ALERT SERVICE BULLETIN

NO. 230-99-17
DATE 12/16/99
PAGE 1 of 4

SUBJECT: TAIL ROTOR PITCH CHANGE BEARINGS P/N 222-312-753-103, INSPECTION OF; AND TAIL ROTOR BLADE ATTACHING HARDWARE, REPLACEMENT OF

HELICOPTERS AFFECTED: Model 230 Serial Number 23001 through 23038

FIGURE 1

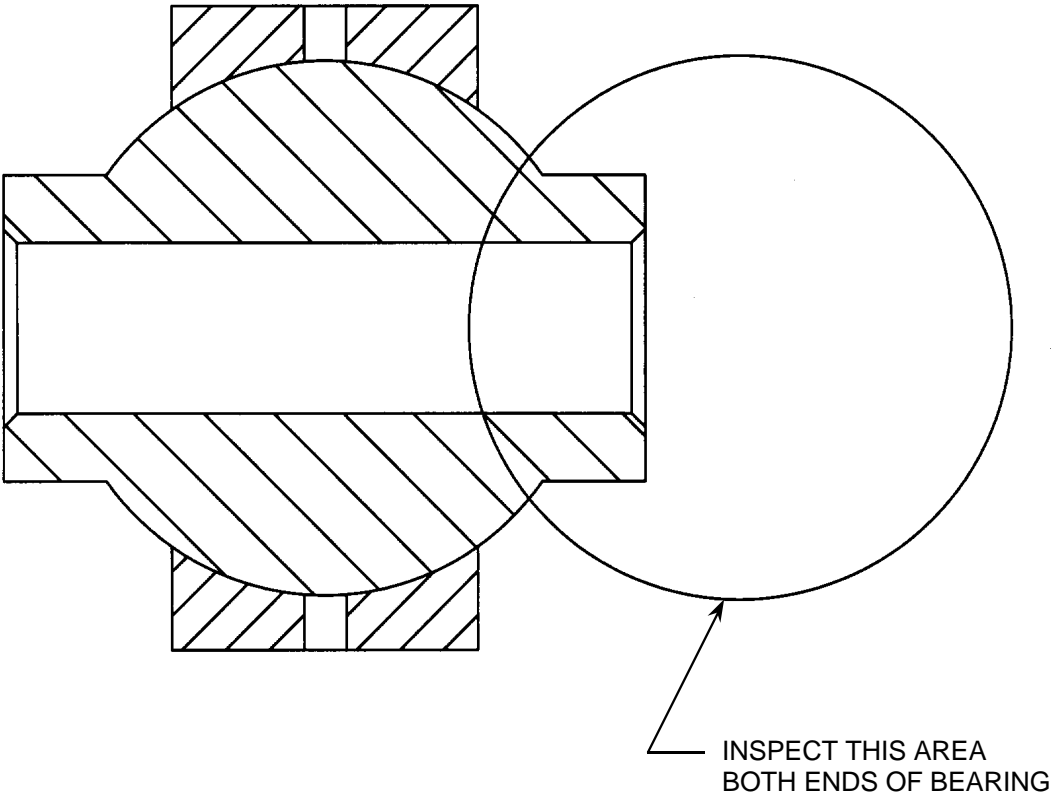
3. Visually inspect each bearing inner member neck area (full 360 degrees) for cracks. Refer to figure 1. If crack(s) are found in a bearing, the replacement of both bearings in that blade are required. Refer to BHT-230-CR&O-3.
